n. 2 Reveley Square

PLAN

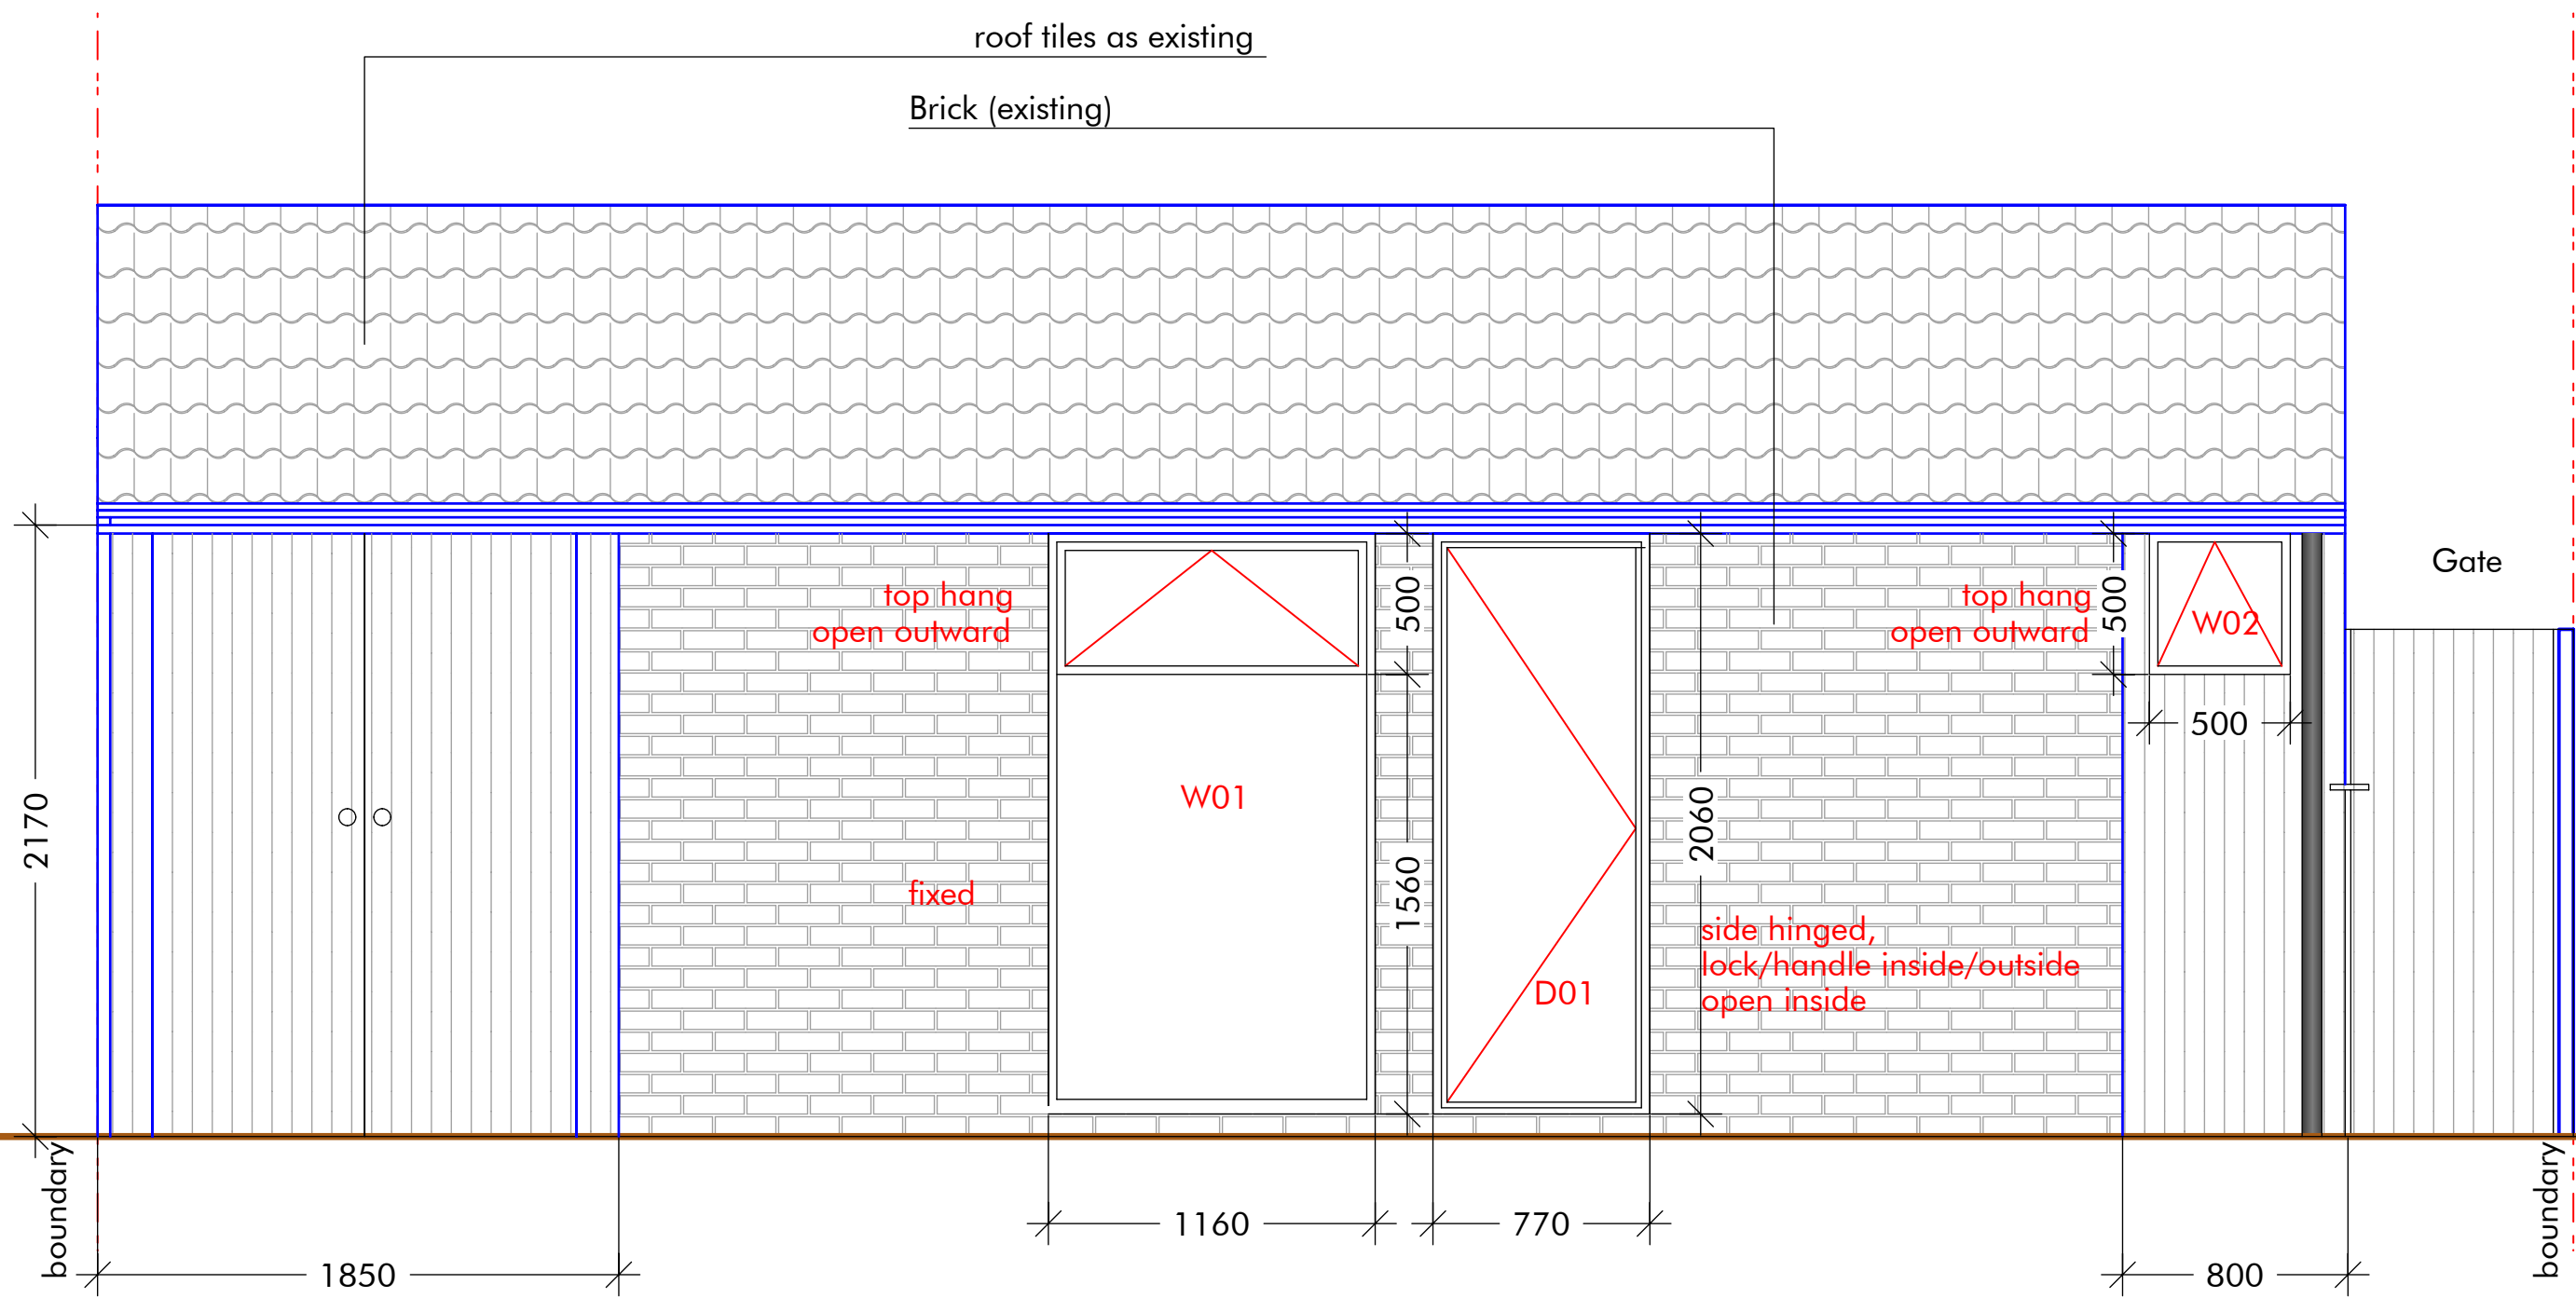
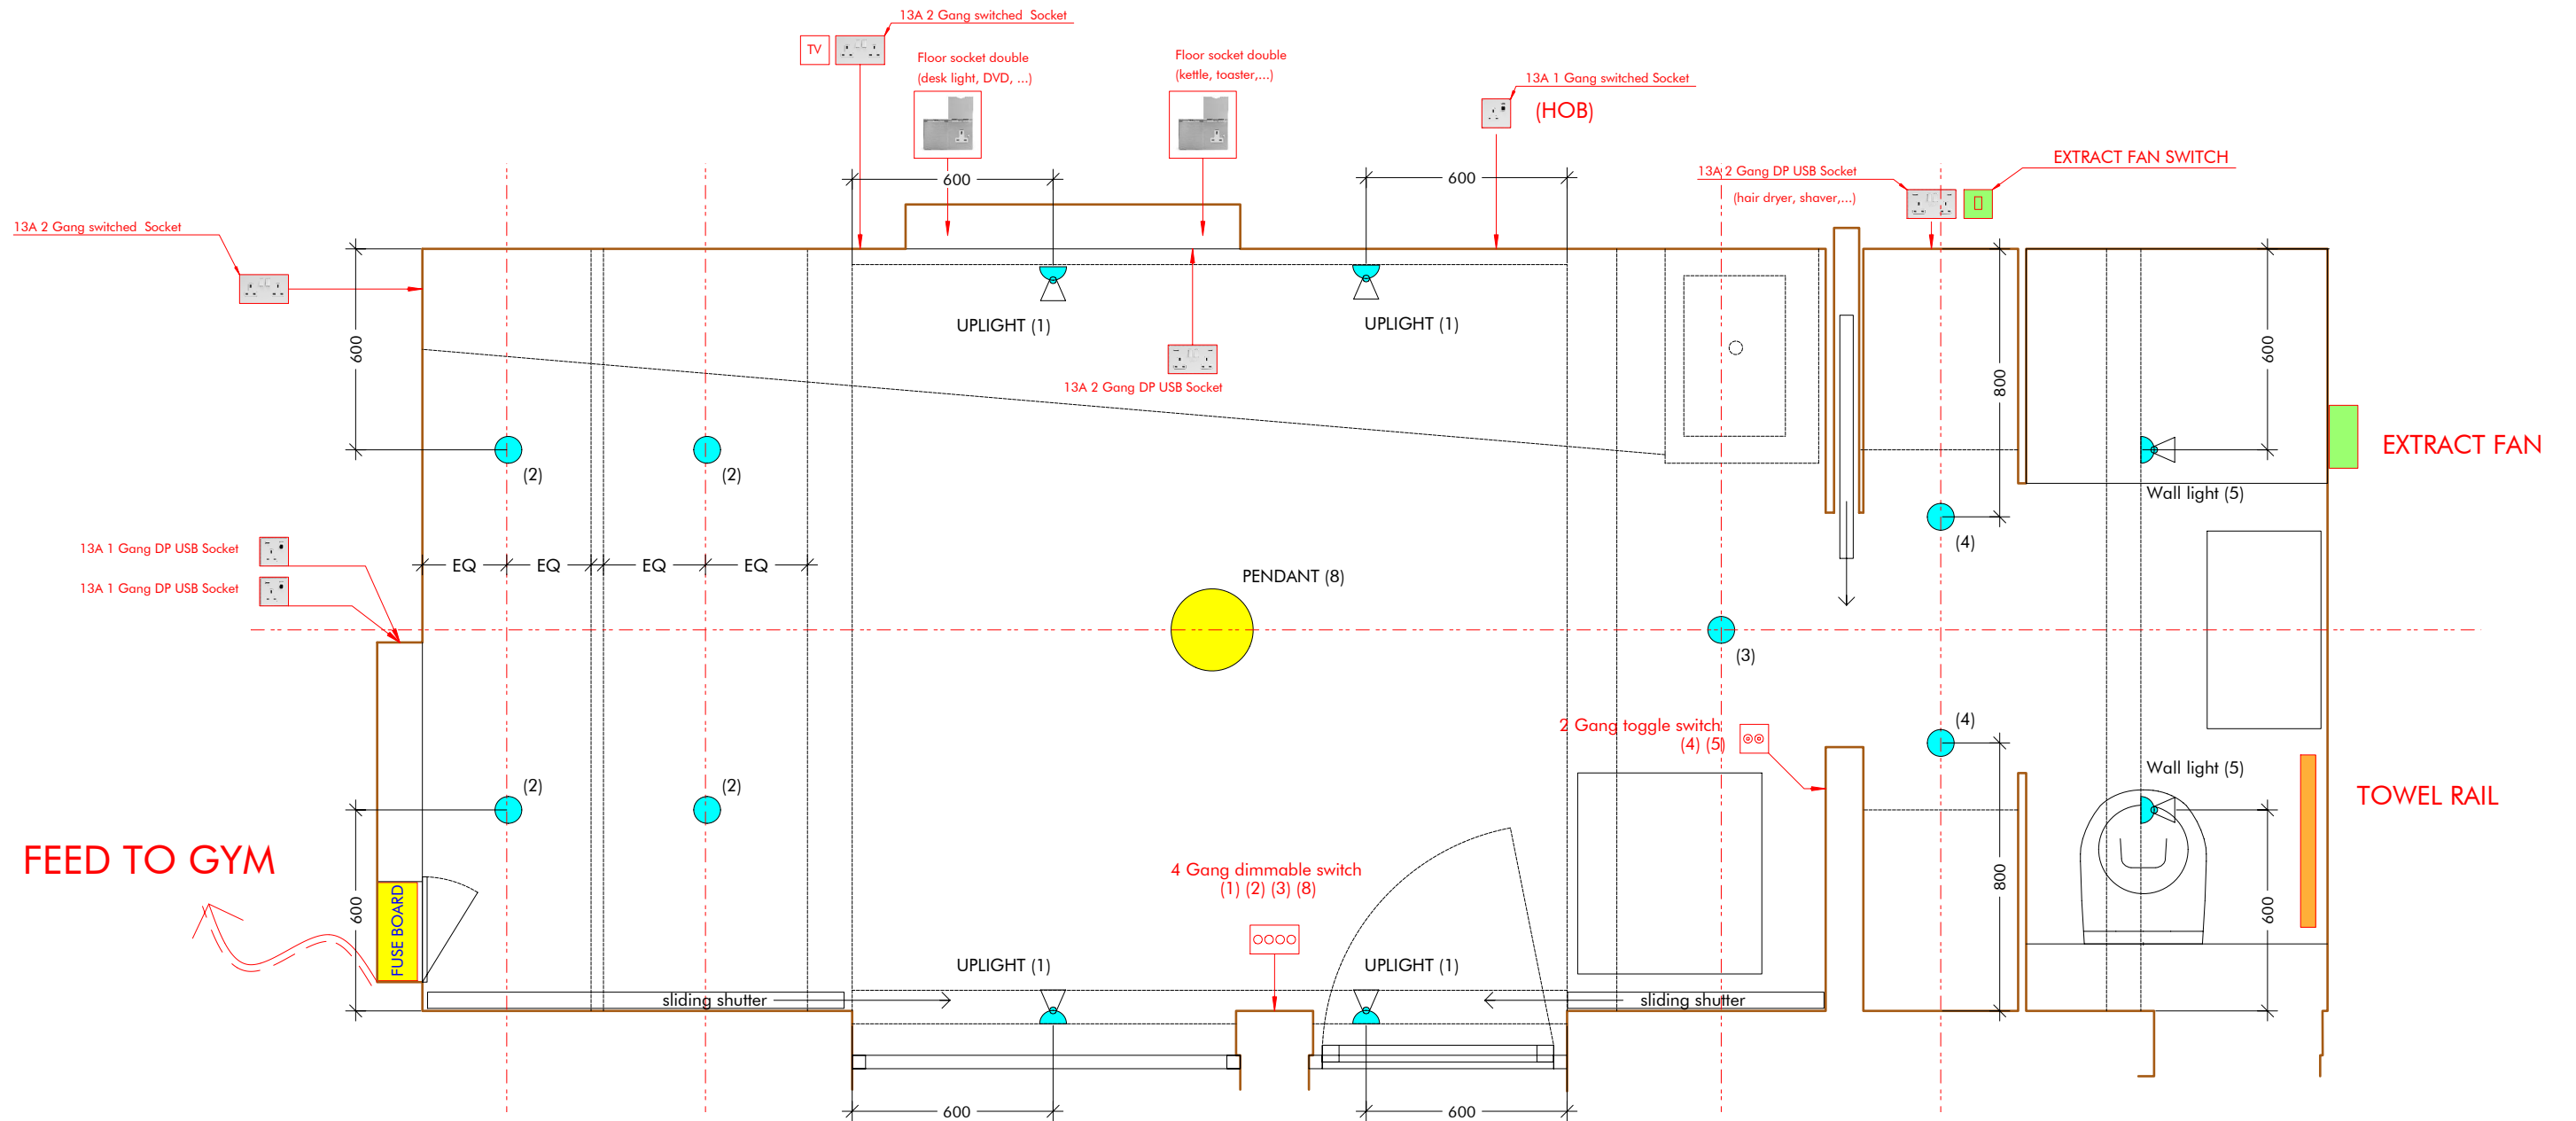
PLEASE NOTE THAT WITH THE CURRENT POSITION OF THE TRIPLE STUDS THERE IS NO ROOM TO RUN PIPES FEEDING WATER AND DRAINAGE
